# CONSERVATION MANAGEMENT PLAN FOR "BLACKIE" A SPECIFICALLY DECLARED STEAM RAILWAY LOCOMOTIVE SAHRA/HO/07/2014

DRAFT

27 March 2015

#### 10. OVERVIEW OF THE PRASA DISPLAY PROPOSAL

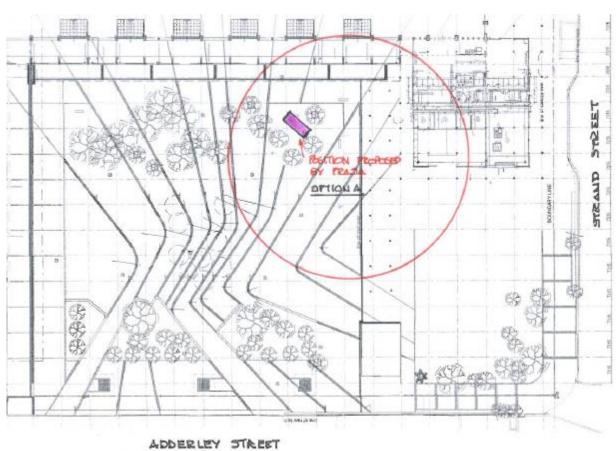
- 10.2. These drawings have been reviewed by B4 Architects and our comments and concerns are set out below:
  - 10.2.1. The design of the roof of the glass display enclosure will result in dirt accumulating on top of the enclosure and washing down the sides of the enclosure which will impede viewing and become a maintenance problem.

- 10.2.2. The effects of sunlight and possible fading of the paintwork over time and how display location should be provided with shade.
    - 10.2.2.1. The proposal submitted by PRASA does not address the issue of protecting the locomotive from the effects of sunlight.

- 10.2.2.2. The locomotive will be exposed to extreme temperature fluctuations and this will result in corrosive climatic conditions within the enclosure.

- 10.2.3. Control of humidity inside the display enclosure and the provision of suitable ventilation to minimise corrosion.
    - 10.2.3.1. The proposal submitted by PRASA does not address this issue.

- 10.2.3.2. The provision of ventilation louvres at high level along the sides of the enclosure will interfere with the climate control and will allow dirt and dust to enter the enclosure.

- 10.2.3.3. Without a proper climate control system condensation within the enclosure and on the locomotive will be a problem and could damage the locomotive.

- 10.2.4.1. The PRASA proposal does not provide sufficient space within the enclosure around the locomotive for maintenance staff to move about and clean both the inside of the enclosure as well as the locomotive without damaging the locomotive.

- 10.2.4.2. The PRASA proposal does not provide sufficient space above the locomotive between the cab roof and the underside of the display enclosure roof to allow for proper access for cleaning and maintenance to the lighting system.

- 10.2.5. Review of the specifications for the glass.
    - 10.2.5.1. No details are contained on the PRASA drawings or have been provided subsequently by PRASA.

- 10.2.5.4. Based on the information available the proposed enclosure is not suitable.
  - 10.2.6. Review of the specifications for the illumination of the locomotive during the hours of darkness.

- 10.2.6.1. The limited information of the lighting system that is shown on the PRASA drawings do not have any details of the specifications for the lighting.

- 10.2.6.2. From inspection of the drawings the lighting system that is shown is not suitable.
  - 10.2.7. Consideration of appropriate security for the locomotive.

- 10.2.7.1. No mention is made in the PRASA proposal of any perimeter alarm or CCTV system.
  - 10.2.8. Consideration of viewing conditions to enable the locomotive to be viewed satisfactorily under all conditions.

- 10.2.8.1. We do not believe that the enclosure proposed by PRASA will satisfy the requirements for satisfactory viewing conditions due to the exposed nature of the glass enclosure and lack of climate control.

- 10.2.8.2. The design of the roof of the glass display enclosure will result in dirt accumulating on top of the enclosure and washing down the sides of the enclosure which will impede viewing and become a maintenance problem.

- 10.2.2.3. Should PRASA still want to display the locomotive in the station forecourt then a proper structure will need to be erected that will provide shade and control exposure to direct sunlight whilst not obstructing the view of the locomotive.

| 10.2.11.  | . A review has been carried to determine whether the proposed location is the most suitable available location in Cape Town for the display of the locomotive.                         |
|---|--|
| 10.3. We  | e do not believe that the enclosure proposed by PRASA will provide acceptable conditions for the display of the locomotive and recommend that alternate display options be considered. |

#### 11.2.1.2. Option A2 – PRASA Proposed position but with proper display building to house the locomotive – External access

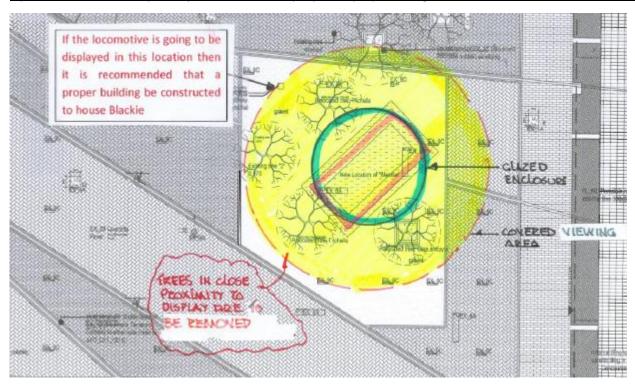
- 11.2.1.2.1. Good display position and would be in the position already approved by PRASA.
- 11.2.1.2.2. Would not interfere with pedestrian flow.
- 11.2.1.2.3. Special building with external shaded area will have to be built around the display enclosure.
- 11.2.1.2.4. Building will have to be climate controlled.
- 11.2.1.2.5. Viewing of locomotive will be through glazing.
- 11.2.1.2.6. Costs could be a problem.
- 11.2.1.2.7. The costs are likely to be greater than creating a display within the Concourse.
- 11.2.1.2.8. Would be an acceptable option.

#### 11.2.1.3. Option A3 – PRASA Proposed position but with proper display building to house the locomotive – Internal access

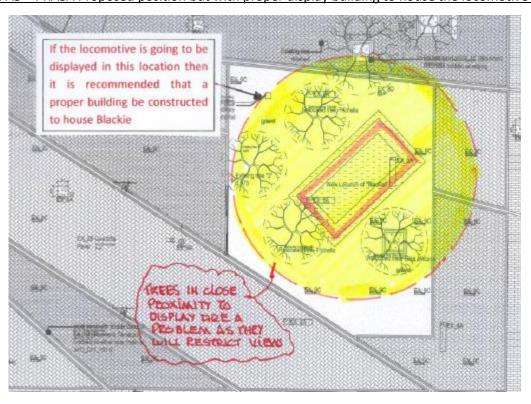
- 11.2.1.3.1. Good display position and would be in the position already approved by PRASA.
- 11.2.1.3.2. Would not interfere with pedestrian flow.
- 11.2.1.3.3. Special building to be built to house "Blackie" within an enclosed viewing area.

- 11.2.1.3.4. Building will have to be climate controlled.
- 11.2.1.3.5. Access to the building would have to be controlled and security systems put in place.

- 11.2.1.3.6. Good viewing conditions viewing of locomotive will be by entry into the building.
- 11.2.1.3.7. Easy maintenance of the locomotive.
- 11.2.1.3.8. Ability to display other historical artefacts and documents relating to the development of the railways and railway station in Cape Town.

- 11.2.1.3.9. Costs and security management could be a problem.
- 11.2.1.3.10. The costs are likely to be greater than creating a display within the Concourse.

- 11.2.1.3.11. Would be an acceptable option.

#### 11.2.2.2. Option B2 – Central Position in Main Line Concourse

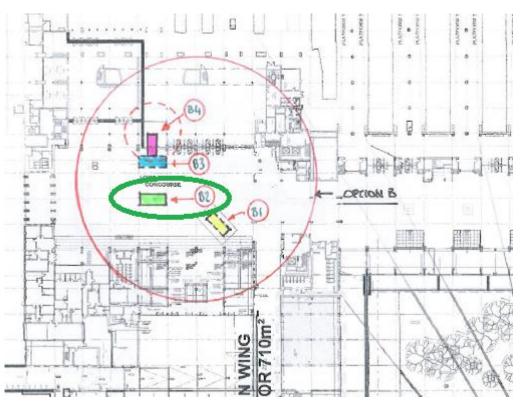
- 11.2.2.2.1. Mosaic panel will have to be uplifted and relocated.
- 11.2.2.2.2. Readily visible from all sides.
- 11.2.2.2.3. Will have some interference with pedestrian traffic flow in the Concourse but pedestrians can flow around display.
- 11.2.2.2.4. Will interfere with the overhead information boards in the middle of the concourse.
- 11.2.2.2.5. Would NOT be a recommended option.

#### 11.2.2.3. Option B3 – Offset towards Main Line platforms in Concourse

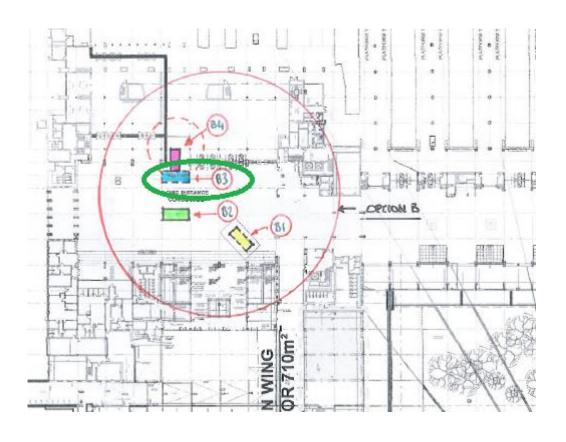
- 11.2.2.3.1. Mosaic panel will have to be uplifted and relocated.
- 11.2.2.3.2. Visible from all sides.
- 11.2.2.3.3. Will have minimal interference with pedestrian traffic flow in the Concourse
- 11.2.2.3.4. Position probably acceptable to PRASA.
- 11.2.2.3.5. Not preferred option.
- 11.2.2.3.6. Could be an acceptable option.

#### 11.2.2.4. Option B4 – Alcove near Main Line platforms in Concourse

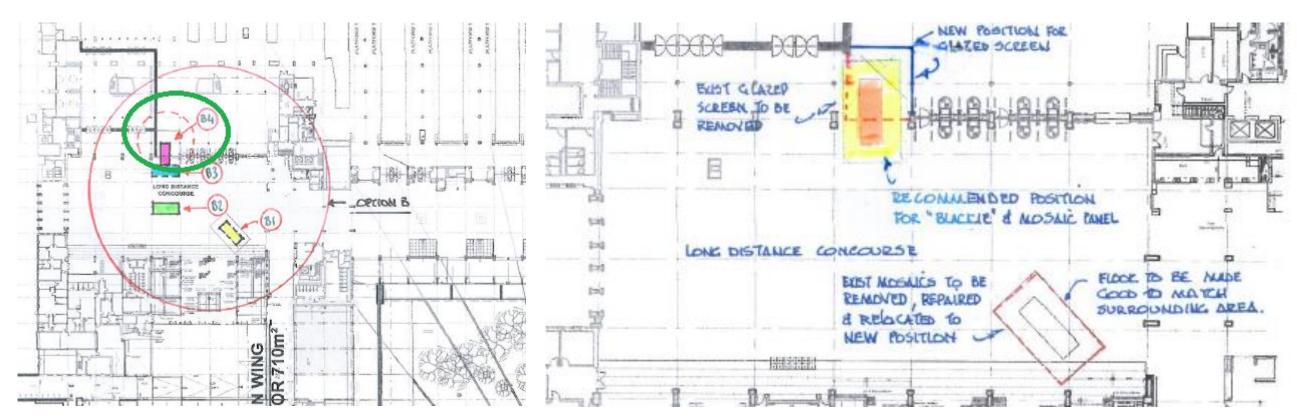
- 11.2.2.4.1. Mosaic panel will have to be uplifted and relocated.
- 11.2.2.4.2. Will have no interference with pedestrian traffic flow in the Concourse.
- 11.2.2.4.3. Will require modifications to existing glazed screen between Long Distance and Metro waiting areas.
- 11.2.2.4.4. Visible from all sides position will provide good display position with minimal interference with other activities within the Concourse.
- 11.2.2.4.5. Ceiling of Concourse will need to be repaired before "Blackie" is placed on display.
- 11.2.2.4.6. Position suggested by PRASA and acceptable to PRASA.
- 11.2.2.4.7. Does have cost implications due to the modifications to the existing glazed screen.
- 11.2.2.4.8. Would be an acceptable option
- 11.2.2.4.9. Preferred location within Concourse.
